3.0 Design Drivers & Evolution

The scheme was taken to a DRP (Chair's Review) on 2nd March 2018 with Peter Studdet and Kay Hughes acting as reviewers. The panel supported the design and massing of the scheme. They had suggestions to improve details of the facade and wanted to see elements of the internal apartment layouts improved. Comments that required a response are noted below together with the subsequent action of the Design Team (DT) in blue.

3.1.1: Pre-App 01 massing

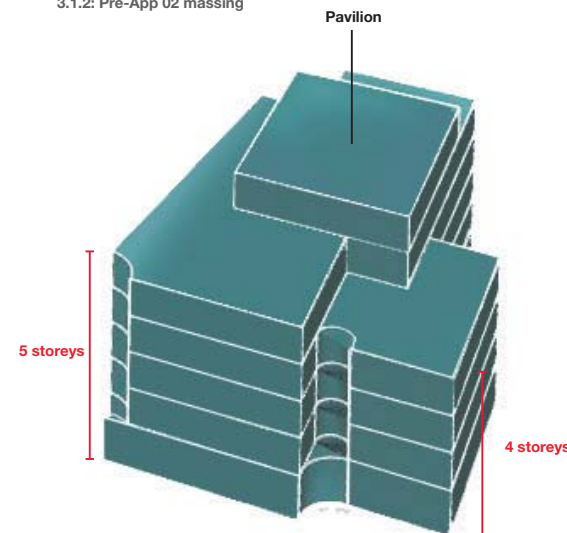
- No particular concern was raised with regard to overlooking the school. Notwithstanding this, a further setback to the massing at the rear was suggested.

- Support was given to the proposed extension of the development to the existing pavement edge on Chalk Farm Road, as this is also the case in the Marine Ices development.

- The proposed G+4 massing facing Haverstock Hill was deemed acceptable. However, the G+6 massing at the rear was not.
- Support was given to the massing strategy of breaking the form into separate volumes.

- No service bay was required to the retail units on the basis that the existing retail units along Haverstock Hill and Chalk Farm Road do not feature servicing bays.

3.1.2: Pre-App 02 massing

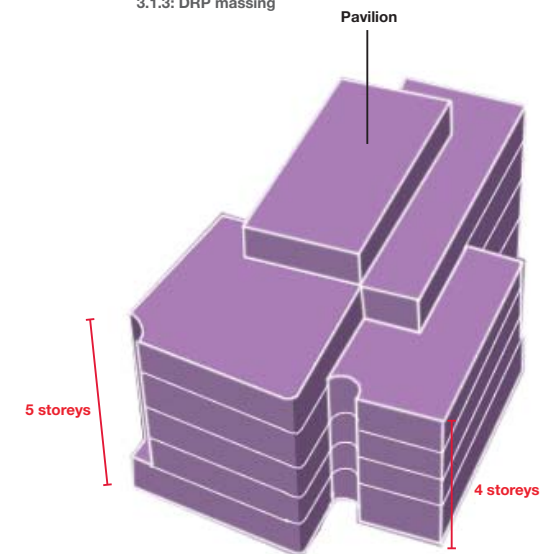
- The rooftop pavilion reads as an additional storey which was thought unacceptable.
- Overall heights needed to be adjusted to align with neighbouring developments.
- Glazing and facade positions on the west side should be reconsidered so as not to prejudice development on the neighbouring site.
- The proportions and articulation of the front facade and the exact location of the sculptural corner elements need further design development.

- The top floor pavilion reduced in height and area further lessening its visual impact on long and short street views.
- The tops of the front two blocks have been reduced in height so as to relate better to neighbouring developments.
- The front facade is angled out, following the street line, creating a less abrupt corner facing Haverstock Hill and a more dynamic corner composition addressing Chalk Farm Road.
- Windows are removed from the western boundary facade and the northern portion of this elevation is set back 3m from the site edge.
- The composition of the facade has been simplified.

DRP Design Image

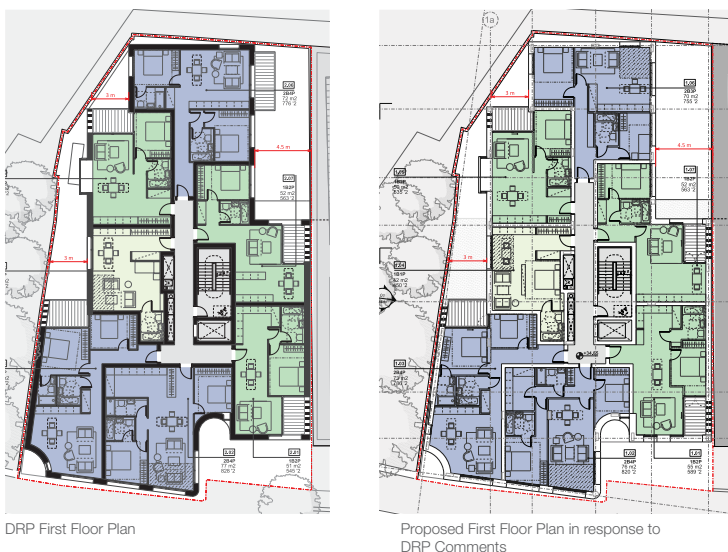
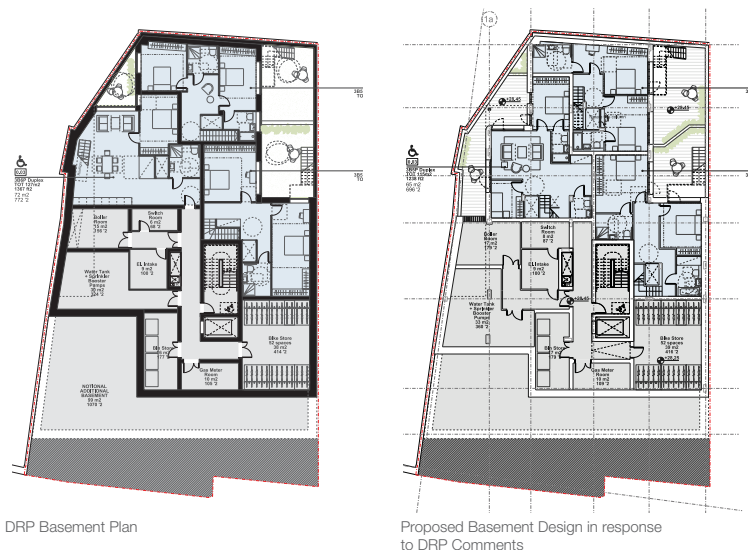
DRP (Architectural Expression): The majority of buildings on Chalk Farm Road are characterised by separate top and bottom sections, but this building is designed as a single object with one facade material. The panel suggests the architects look further at whether their designs can do more to reflect the character and distinctiveness of their surroundings.

DRP (Architectural Expression): The use of white facade tiles (bricks) is problematic for a site next to a busy road. They are likely to become dirty very quickly, particularly on the prominent west-facing elevation. A darker material that can be washed down, such as faience, may be a better choice.

DRP (Architectural Expression): The facade should be designed to accommodate the shop signs that will be needed once the ground floor retail units are occupied. These should be designed into the building from the start, and may also help to introduce exuberance into the architecture and reflect the Chalk Farm Road surroundings more directly.

DRP (Architectural Expression): The architecture of the distinctive west corner, facing towards Haverstock Hill, needs to be further developed to create the strong feature envisaged. A different material might help to enliven the corner, while lengthening windows could also strengthen the design.

DRP (Relationship to neighbours): The panel notes that the blank west facade facing the vacant, council-owned site between the development and Haverstock Hill School has been introduced in case the school expands. However, as this is not thought to be likely, the restrictions placed on development at 18-22 Haverstock Hill seem unnecessary. The panel suggests that the possibility of the vacant adjoining site being included in the development should be fully explored.

DRP (Site Coverage): The site coverage has created basement garden spaces which are both too dark and too small. In particular, the north-west basement garden will be one and-a-half storeys below ground, and too small and dark for a flat designed for family use. Pressure on spaces at the rear of the development should be reduced, and the basement may need to be made smaller to avoid spaces that are too deep in the slope at the back of the site.

DRP (Internal Layout): The single-aspect, north-facing basement accommodation is of particularly poor quality and should be reorientated.

DRP (Internal Layout): The plans include long basement corridors, which are likely to be dark. These should be reduced in length to create more pleasant spaces.

DRP (Internal Layout): Bicycle storage in the basement, accessible only via the single shared lift, is awkward and residents will be much less likely to use it. This should be relocated to the ground level.

DRP (Internal Layout): The location of the rubbish bins in the basement is likely to cause problems, as they will have to be taken up in the single lift and through the lobby, which will undermine the quality of the space.

DRP (Internal Layout): The ground floor entrance should be wider and more generous, creating a lobby with a sense of arrival, as well as room for delivery space and letter boxes.

DRP (Internal Layout): The south-east corner units above the main entrance on Levels One, Two and Three will only be lit from the front by a small window. This is not sufficient, and such deep spaces will require more window space.

DRP (Internal Layout): The recessed facade area next to the main entrance also includes windows on Levels One, Two and Three which are very small in relation to the rooms they serve.

DRP (Internal Layout): The southern section of the central corridor on Levels One, Two and Three would provide more useable space if it was included within the unit to the east, rather than as part of the corridor.

DRP (Internal Layout): A single lift may not be sufficient to serve a building of this size. Although accessible flats are located on the ground floor, it is not only people with acknowledged access needs who will be inconvenienced when the lift is out of service, particularly if it is required for bicycle storage and rubbish collection.

DRP (Internal Layout): The amenity space at roof level is likely to require communal storage for items used in the space, such as chairs.

DRP (Relationship to neighbours): The mature cherry tree on the vacant site is an asset, and the applicants should fully explore options for retaining it.

DRP (Relationship to neighbours): The building is set back from the neighbouring Salvation Army building on the east side of the site. However, the balconies that project towards the building may still restrict its future development and it may be preferable to locate them on the east side of the building instead.

DT Response: The ground floor and first floor facade material has been changed from a white brick to a white glazed brick. This subtly differentiates a 'base' and a 'top' to the building (further differentiation is given by the large amount of glazing at ground floor level). The glazed brick is non-porous and is therefore easy to clean. It also references the ceramic ground floor treatment to a number of corner buildings on Chalk Farm Road.

DT Response: The ground floor glazing has been raised in height. This provides space for a signage zone within this area. See section 4.0 for detailed shopfront elevations and sections.

DT Response: The small windows in the concave corner curve have been removed. New full height windows on the west facade have been introduced. Many of the existing corner buildings on Chalk Farm Road feature windows mirrored about a corner. This accentuates the corner and the revised design matches this contextual element by introducing full height windows and a recessed brick bay on the previously blank west facade.

DT Response: The north-west duplex unit's garden has been more than doubled in size by cutting back the site coverage on the west and north sides. Adding a courtyard on the west side means that all three of the duplex units are now dual aspect. These units all comply with daylighting standards and offer good family apartments with garden spaces.

DT Response: The duplex units have been reconfigured so that they are all entered on the ground floor (upper level). This means that the communal basement corridor will not be used by residents to enter their units.

DT Response: Basement Bike and Bin stores accessed via stairs and lifts are a standard proposal. Locating these at ground floor level with separate access will take up valuable retail area and frontage. The Design Team proposes that these rooms should be kept in the basement.

DT Response: The entrance space is 1.8m wide and includes post boxes/ delivery space. A glazed panel next to the entrance door will give natural light into the space.

DT Response: An additional window (1900mm high x 1050mm wide) has been introduced.

DT Response: These windows have been increased in size and measure 2025mm high x 860mm wide.

DT Response: The corridors in question have been reduced in length. The area is given to the residential units to create a useful lobby space.

DT Response: The Design Team considers that a large single (15-person) lift is sufficient for a development of this size.

DT Response: A storage unit has been included adjacent to the terrace.

DT Response: The applicant's arboricultural survey identifies a total of 6 trees located adjacent to the site, all of which have the potential to be affected by the proposed development. The mature cherry tree (a Category B tree) is growing very close to the site boundary retaining wall and is pushing against the wall, resulting in temporary remedial repairs. Whilst the design team has sought to retain this cherry tree, it has become clear that the existing retaining wall would need to be replaced, irrespective of the nature of the proposals. Given the desire to retain the tree, a meeting was held with the Council's tree officer (Tom Little) and was subsequently agreed that the tree should be removed. In order to mitigate the loss of this tree (and the other very low quality trees i.e. Category C), it is proposed to plant additional, high quality replacement trees, as set out in the proposed landscaping plan.

DT Response: The balconies have been removed. The lost space has been given back as extra internal space to the apartments in question.
